URBAN COLLECTION AT PALMER VILLAGE
 DETAILS
 UTILITY SERVICE PLAN

SHEET 10 OF 11
 JOB NO. 25149.01

WATER CONSTRUCTION PLANS

URBAN COLLECTION AT
PALMER VILLAGE
COVER SHEET
WATER SYSTEM PLAN

Colorado Springs Utilities
 MULTI-FAMILY RESIDENTIAL PREMISES UTILITY SERVICE OPTION #2
 B2-6
 DATED 01/2017

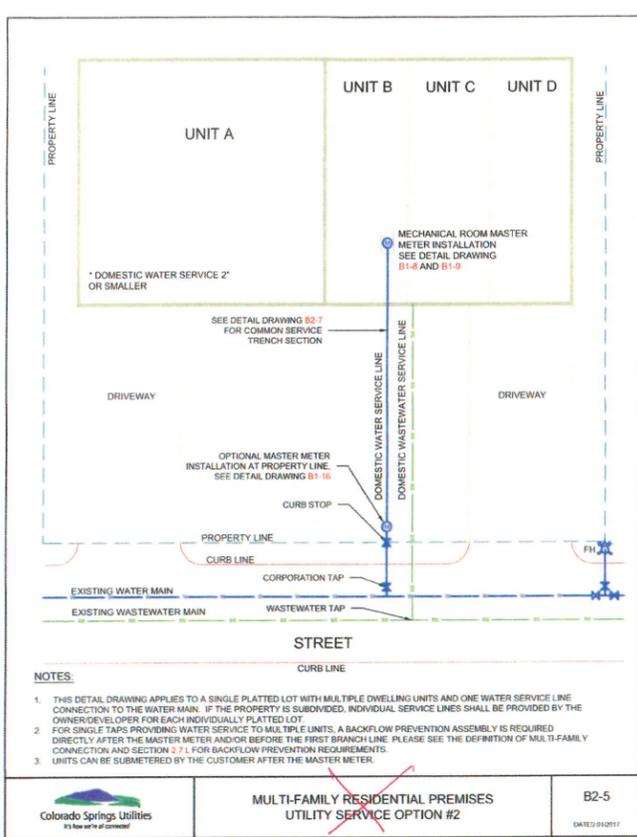
NOT USED ON PROJECT - DELETE

Colorado Springs Utilities
 MULTI-FAMILY RESIDENTIAL PREMISES UTILITY SERVICE OPTION #2
 B2-5
 DATED 01/2017

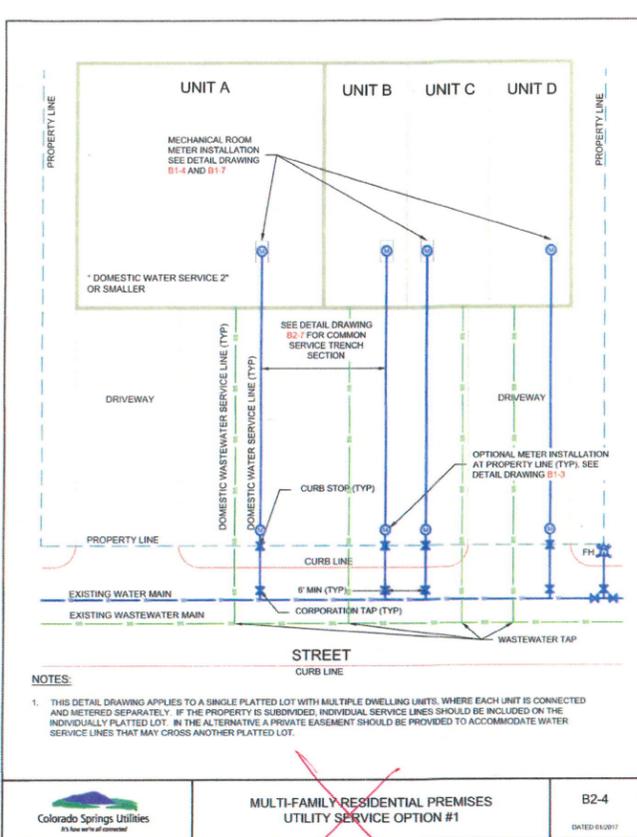
NOT USED - DELETE

Colorado Springs Utilities
 MULTI-FAMILY RESIDENTIAL PREMISES UTILITY SERVICE OPTION #1
 B2-4
 DATED 01/2017

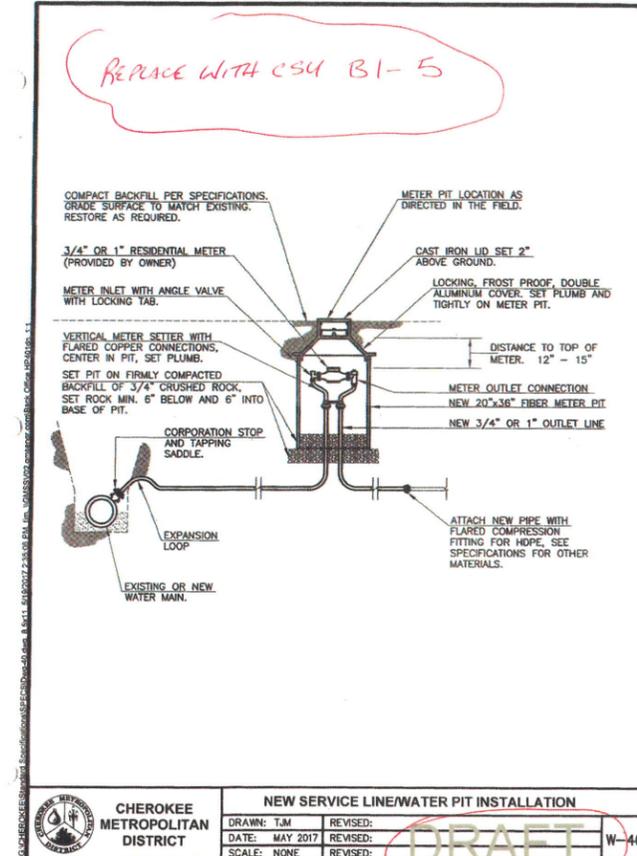
NOT USED - DELETE

CHEROKEE METROPOLITAN DISTRICT
 NEW SERVICE LINE/WATER PIT INSTALLATION
 DRAWN: TJM
 DATE: MAY 2017
 SCALE: NONE

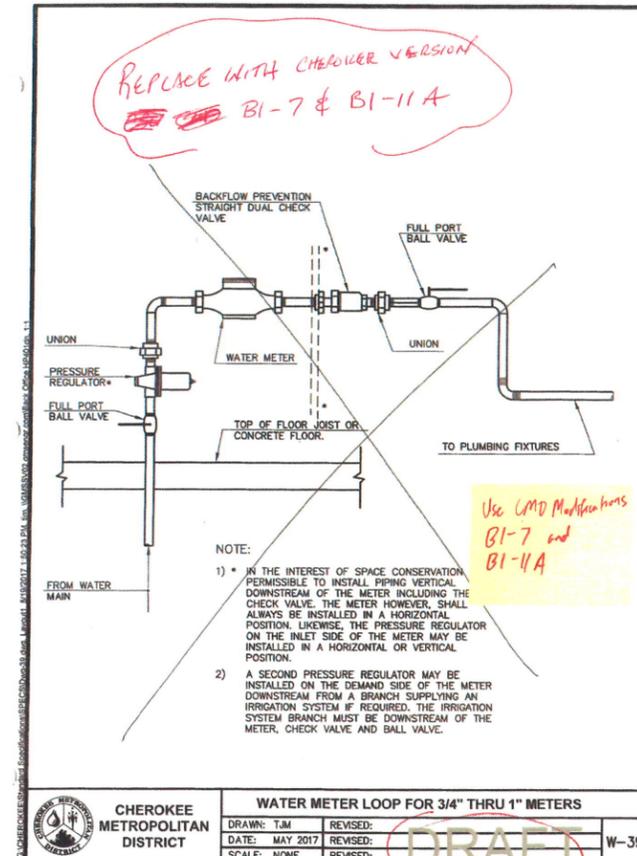
REPLACE WITH CS4 B1-5

CHEROKEE METROPOLITAN DISTRICT
 WATER METER LOOP FOR 3/4\"/>

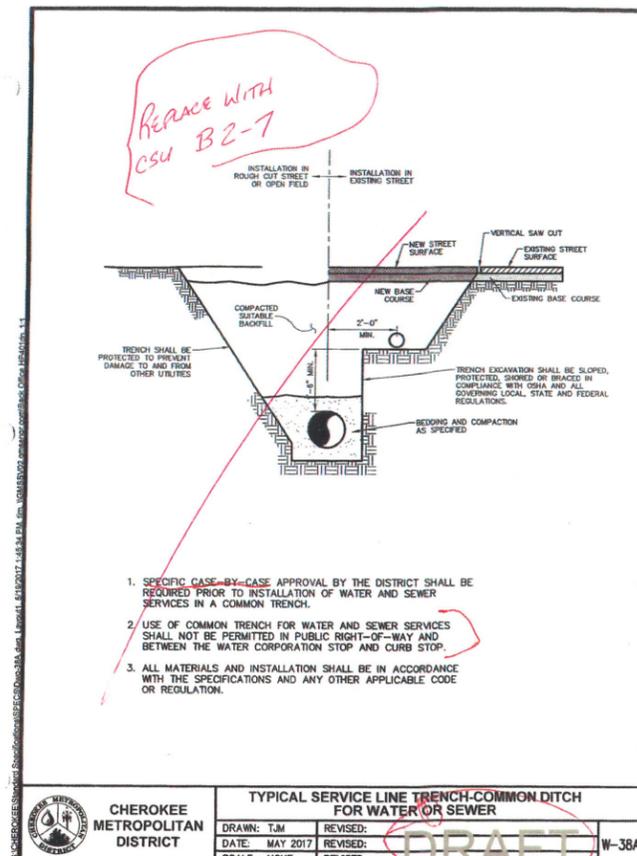
REPLACE WITH CHEROKEE VERSION BI-7 & BI-11A

Use CMD Modifications BI-7 and BI-11A
